State Project No. 029-104

Replacement of Bridge No. 05141 - Sandy Brook Road over Sandy Brook and Preservation of Bridge No. 05146 - Old Creamery Road over Still River

**Public Information Meeting
May 12, 2021 at 6:00 pm
Online via Zoom**

Report of Meeting

Roadway Profile

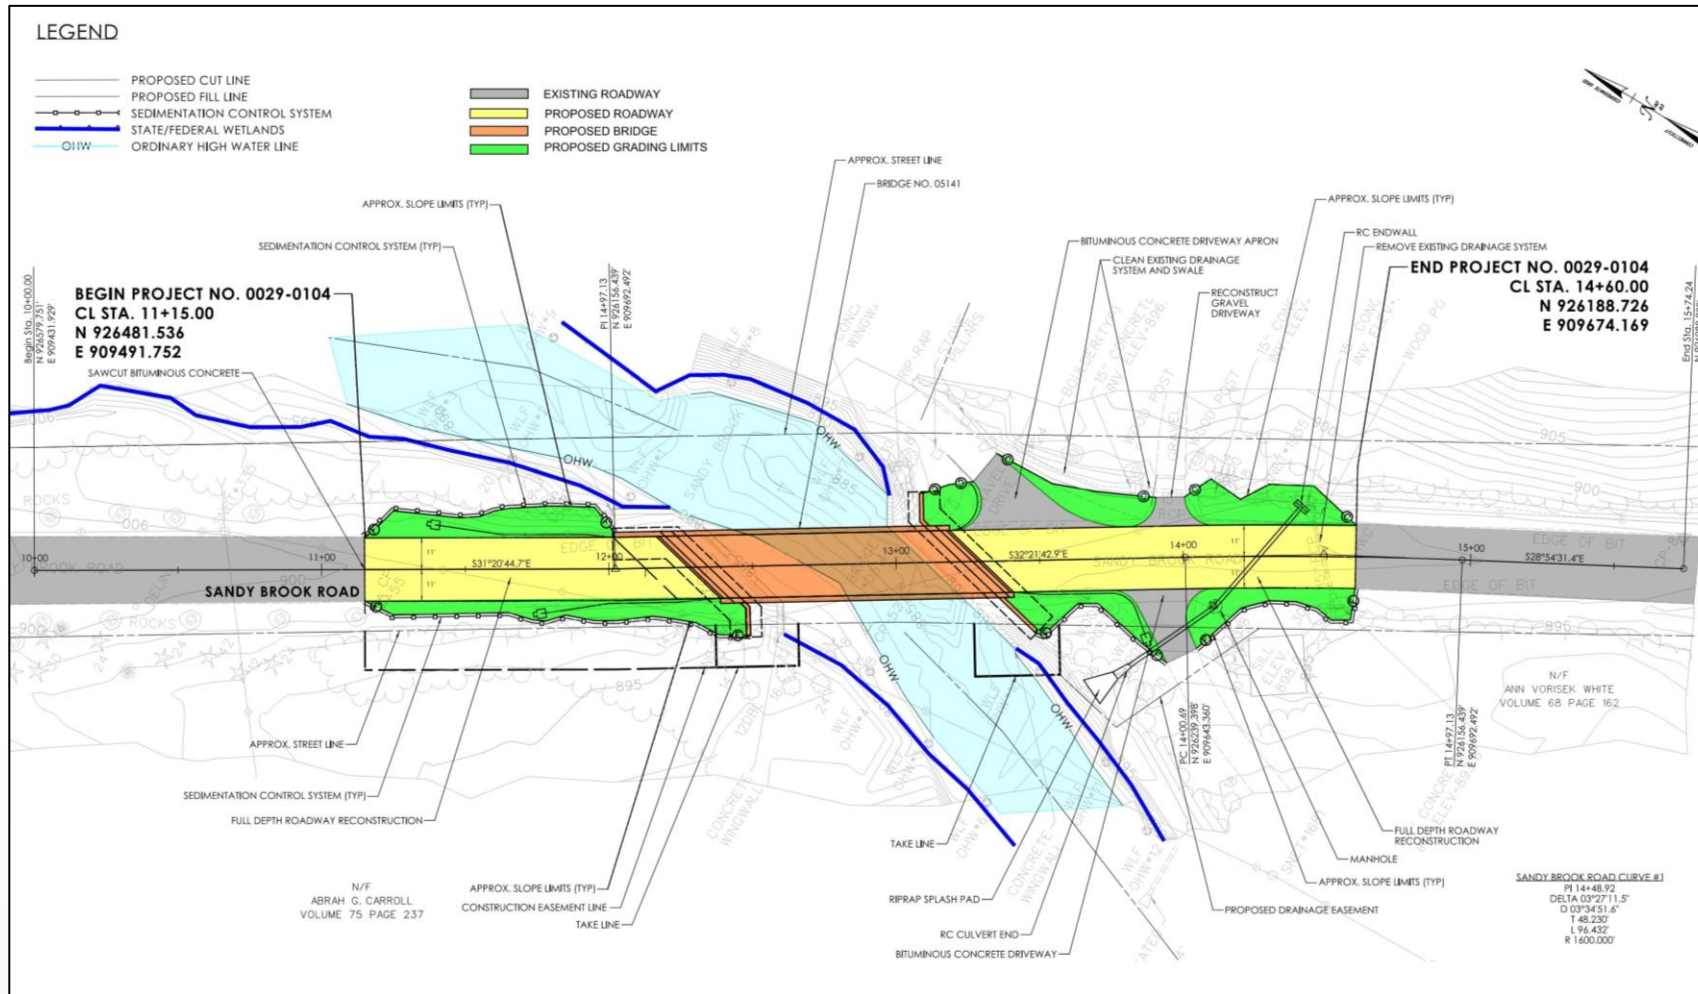
Question 2: Do we gain anything in terms of clearance for flow by doing that?

Question 5: How much more flow capacity is gained? Is it significant with this? Is that 6" of freeboard that significant?

Answer 2: Yes. As mentioned before, it does create some improvements to the hydraulics where we are getting no overtopping to the low point in the road for the 100 -year design storm.

Answer 5: I think it helps. You are not going to get that overtopping that you may get occasionally, once in 10 years. There are definitely some improvements. It doesn't eliminate everything, but there are definitely some sizable improvements.

Rights-of-Way

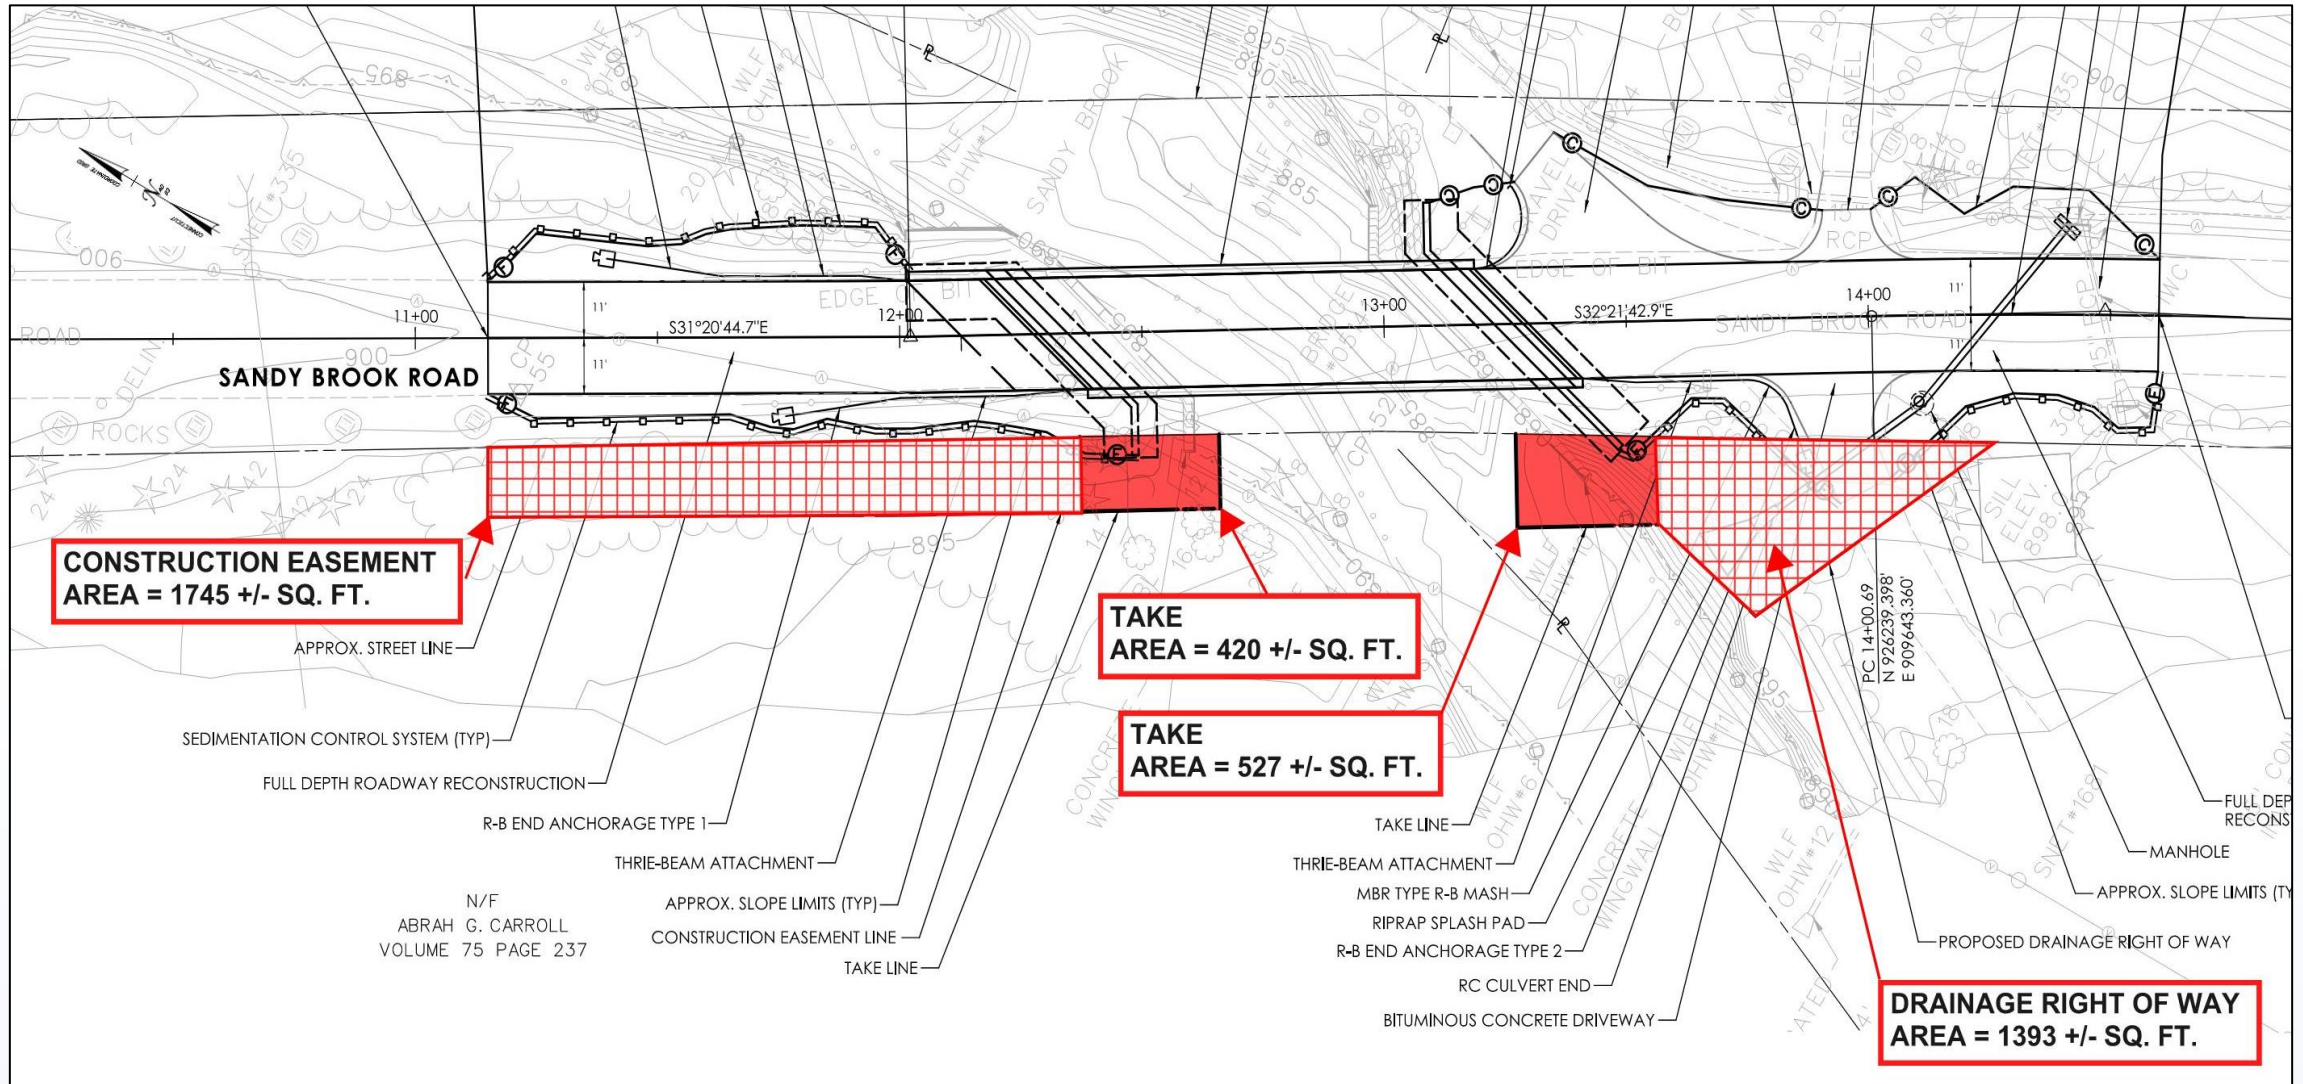
Question 14: Can we look quickly at the taking drawing? What is that going to look like in the final game in terms of the landscape/the terrain on the south side of the bridge?

Question 15: There will be an excavation across my driveway (Harry White's driveway)? Will I be able to get in and out of my driveway during that? Except when the actual hole is being dug?

Answer 14: It is going to look very similar. It is going to be restored. We are raising the profile a little, so there will be some reconstruction to your driveway. For the most part, there is an outfall there now and there will be a new outfall for that cross pipe. It will look similar to what you have now, but some of that vegetation will have to come down to do those changes.

Answer 15: Yes, we will need to trench that to get that new pipe system installed. Yes, that is a requirement during construction that your access is maintained and coordinated with the contractor.

Recommended Proposed Work

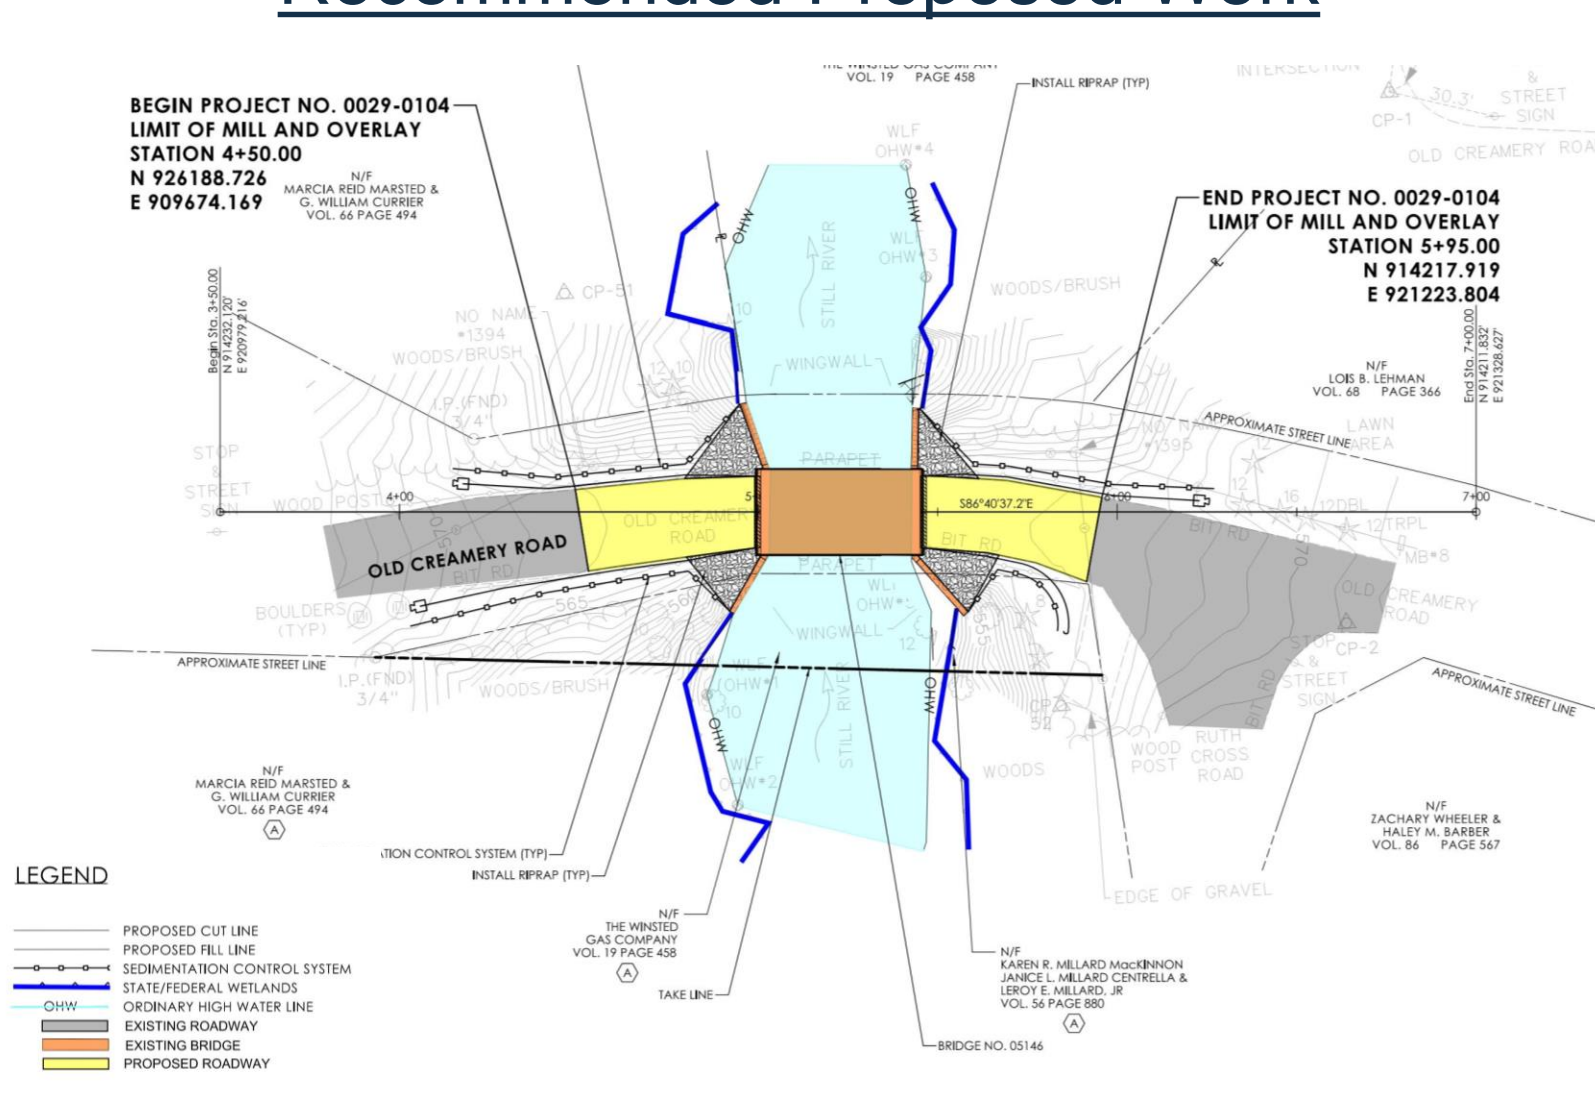
Question 1: Are you taking a lot of trees?

Answer 1: The only work that may require some minor clearing is to install that riprap slope areas within those triangular areas in hatch on the plan. There are some smaller trees in close proximity of the four corners of the bridge. But aside from that, the intention is to not do that much clearing for this type of work.

Rights-of-Way

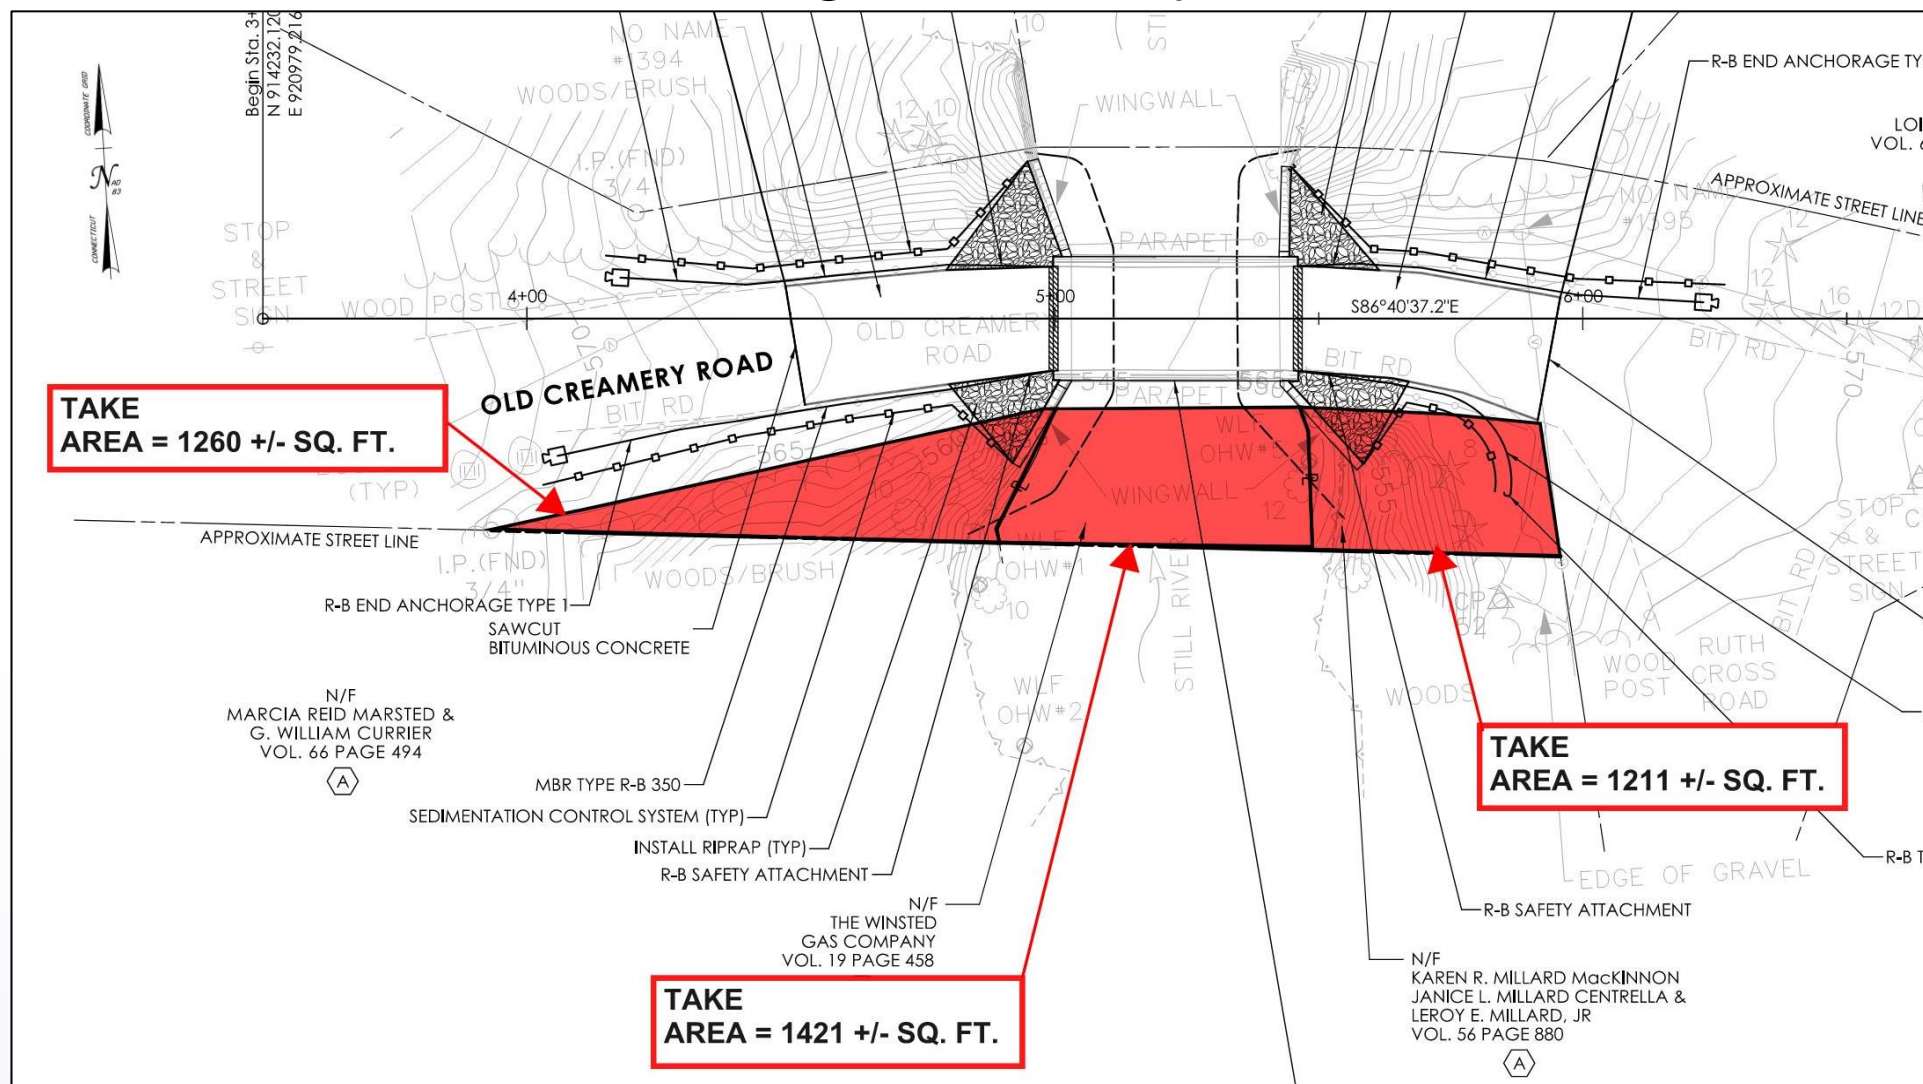
Question 3: Is it possible to get a copy of the take page.

Answer 3: Yes. As part of this process, the CTDOT Rights-of-Way department will be meeting with any of the property owners where there are impacts. So, you will also be having that and contact information can be share as well, which is definitely part of this program.
